ADDENDUM NO. 2

DATE: November 22, 2013

Contract 14-C-00006; Lake Eckles Pump Station and Force Main Replacement

DES: MTM DRN: MP CKD: DATE:	CITY of TAMPA Department of Public Works Stormwater Engineering	LAKE ECKLES PUMP STATION SITE GRADING PLAN	W.O. 510H SHEET C-2 OF 53
--------------------------------------	--	--	---

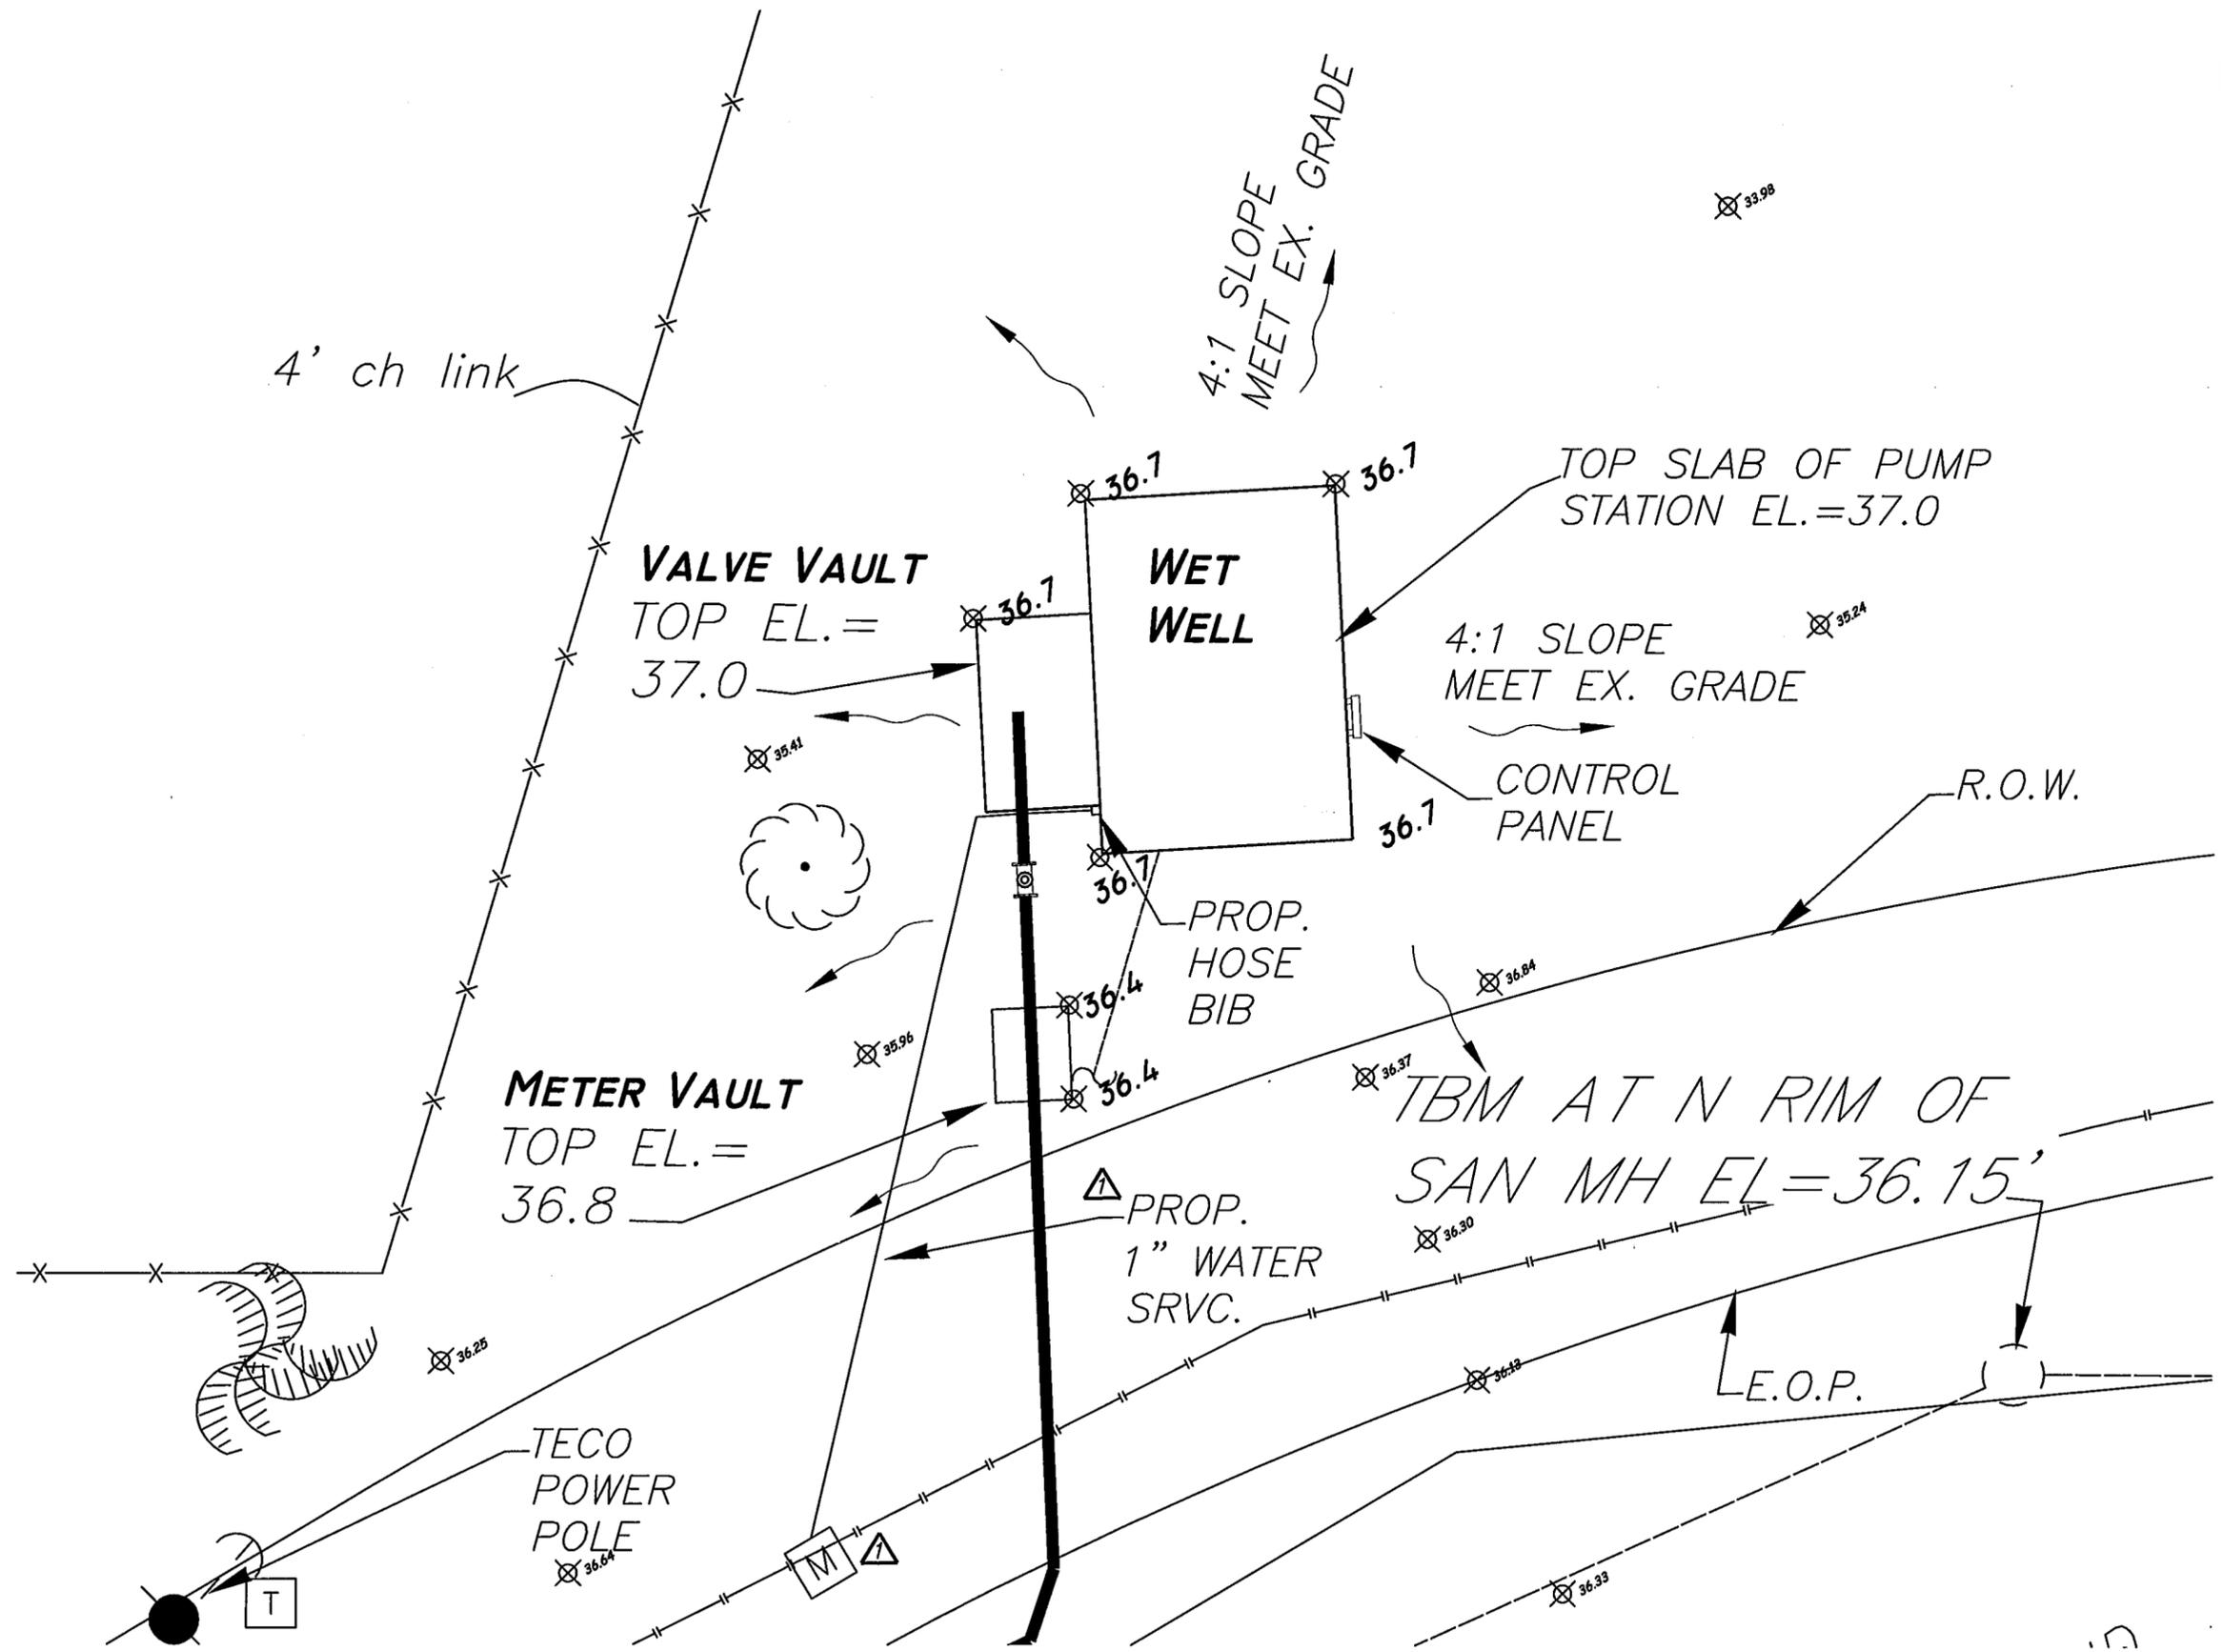
- Item 6: Add, on page C-9 of the Specifications, to Contract Item 0420-2, in the third paragraph, third line after "screen", the following: one 1-inch diameter water service from meter to hose bib location, hose bib and mounting post,

No.	DATE	REVISIONS	No.	DATE	REVISIONS
3			6		
2			5		
1	11/12/13	ADDED NEW WATER METER & 1" SERVICE LINE	4

LAKE ECKLES STORMWATER PUMP STATION
 ELECTRICAL
 SITE PLAN

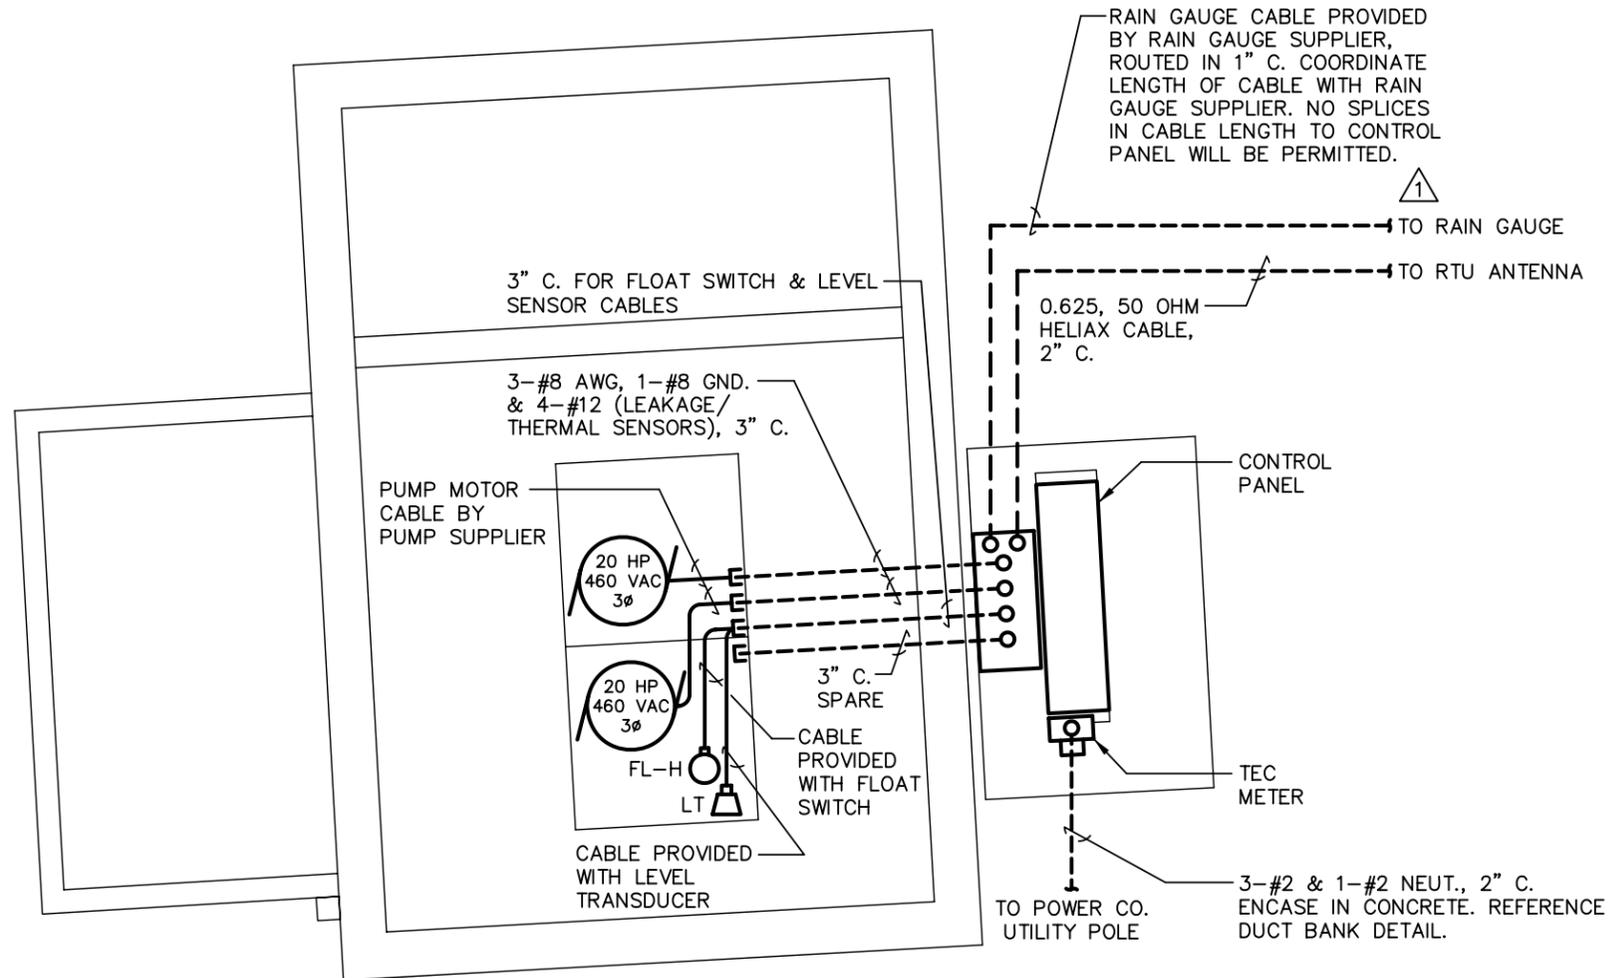
- Item 7: Add, on page C-11 of the Specifications, to Contract Item 6940-10, in the second paragraph, after "station;" the following: rain gauge and associated wiring, mounting and instrumentation,

No.	DATE	REVISIONS	No.	DATE	REVISIONS
3			6		
2			5		
1	11/04/13	ADD RAIN GAUGE	4

5 RAIN GAUGE DETAILS

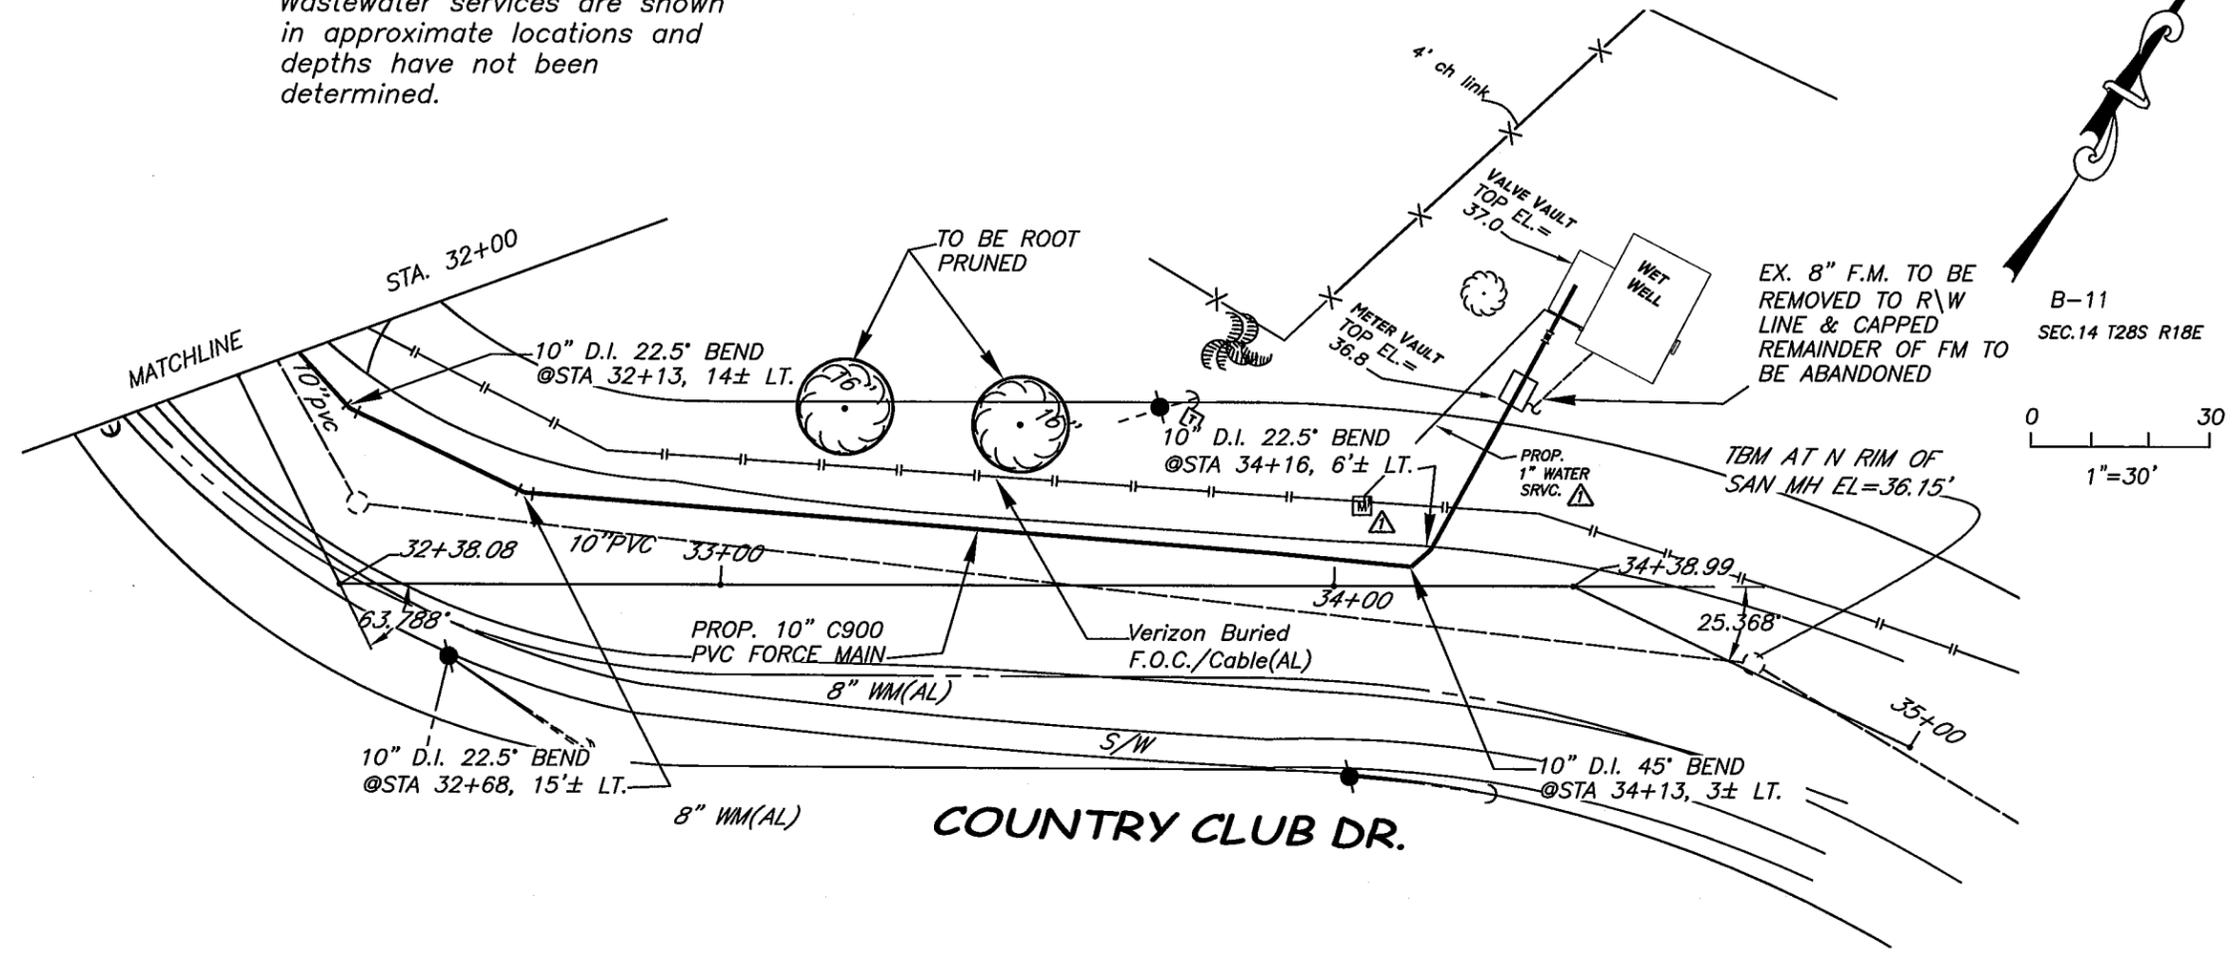
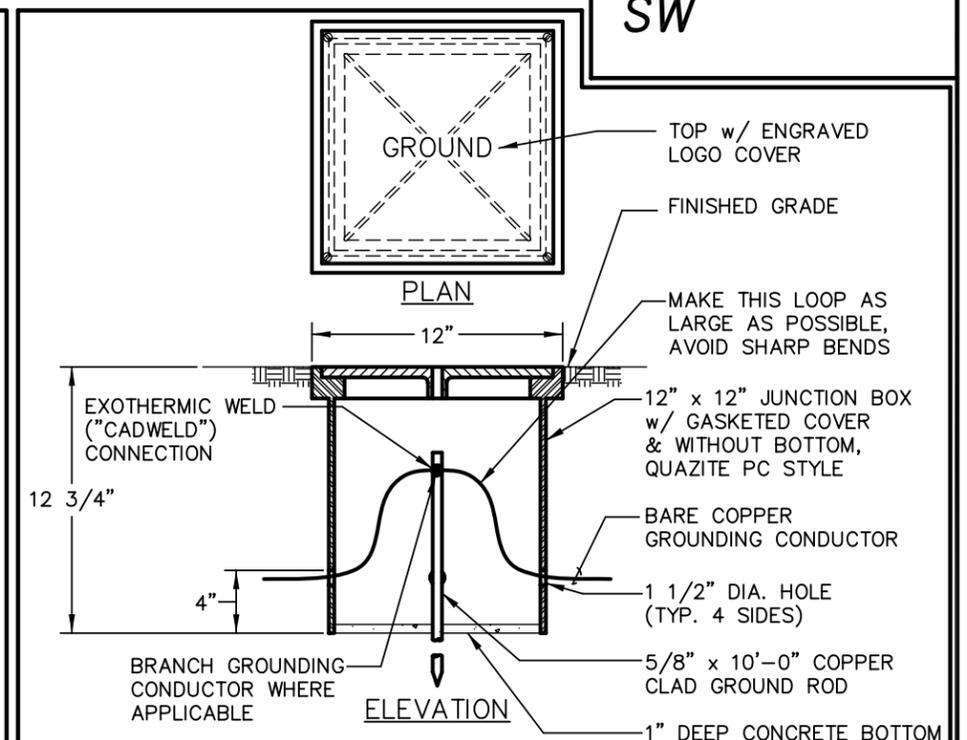
No.	DATE	REVISIONS	No.	DATE	REVISIONS
3			6		
2			5		
1	11/04/13	ADD RAIN GAUGE	4

CAMPBELL SCIENTIFIC MODEL TE525 RAIN GAUGE w/ 6" ORIFICE AND SCALED PULSE OUTPUT. MOUNT RAIN GAUGE TO PIPE USING CAMPBELL SCIENTIFIC MOUNTING KIT AND FOLLOW MANUFACTURER'S INSTRUCTIONS. LOCATE RAIN GAUGE AS SHOWN ON THE SITE PLAN. COORDINATE FINAL LOCATION WITH OWNER.

6' LONG 1 1/2" DIA. SCHEDULE 80 PIPE. WELD CAP ON TOP OF PIPE & HOT DIP GALVANIZE ENTIRE PIPE & CAP AFTER FABRICATION.

RAIN GAUGE CABLE PROVIDED BY RAIN GAUGE SUPPLIER, ROUTED IN 1" C. COORDINATE LENGTH OF CABLE WITH RAIN GAUGE SUPPLIER. NO SPLICES IN CABLE LENGTH TO CONTROL PANEL WILL BE PERMITTED.

W.O. 510H
SHEET
C-15
OF 53

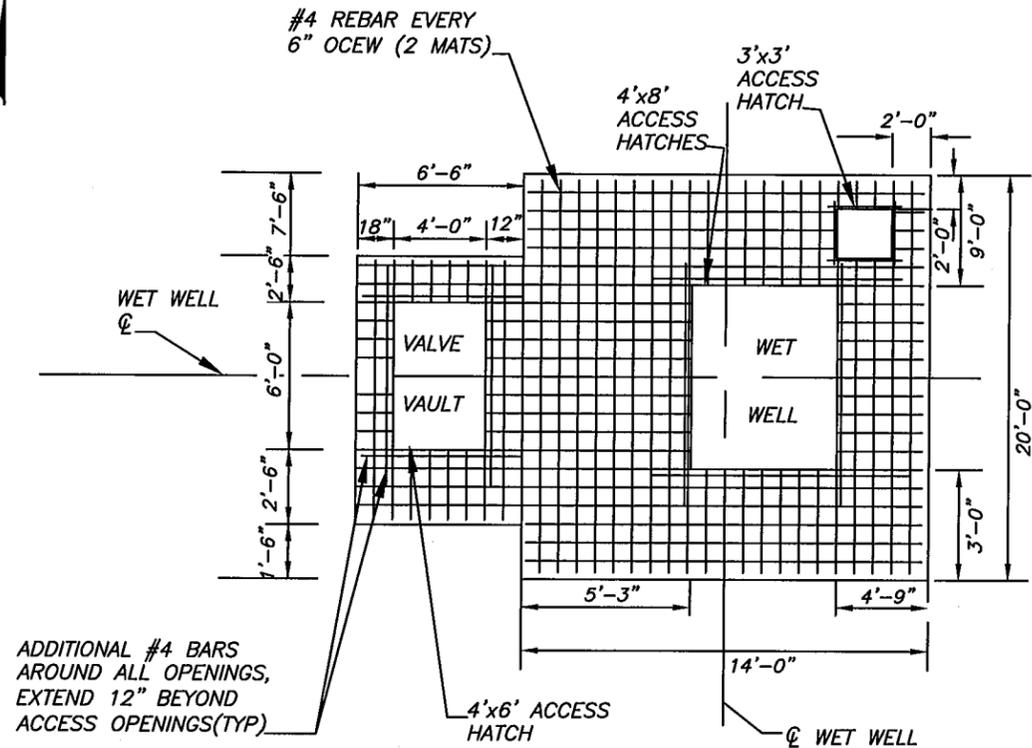
No.	DATE	REVISIONS	No.	DATE	REVISIONS
3			6		
2			5		
1	11/12/13	ADDED NEW WATER METER & 1" SERVICE LINE	4

BAFFLE WALL/FLOOR DETAIL

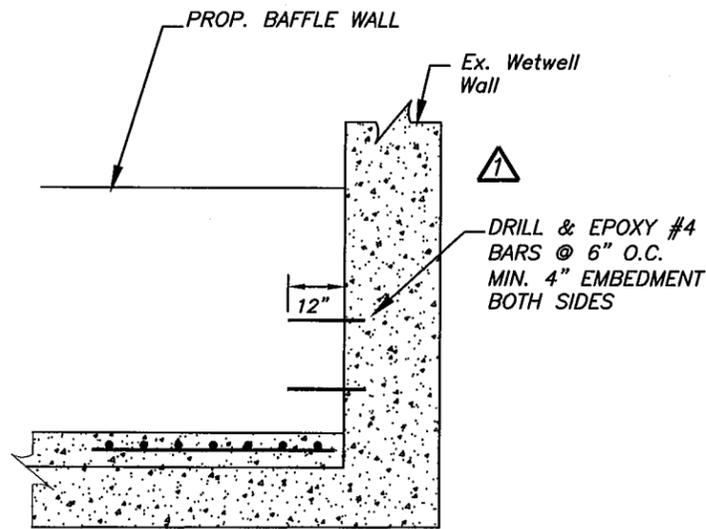
No.	DATE	REVISIONS	No.	DATE	REVISIONS
3			6		
2			5		
1	11/12/13	ADDED NEW BAFFLE WALL DETAIL	4
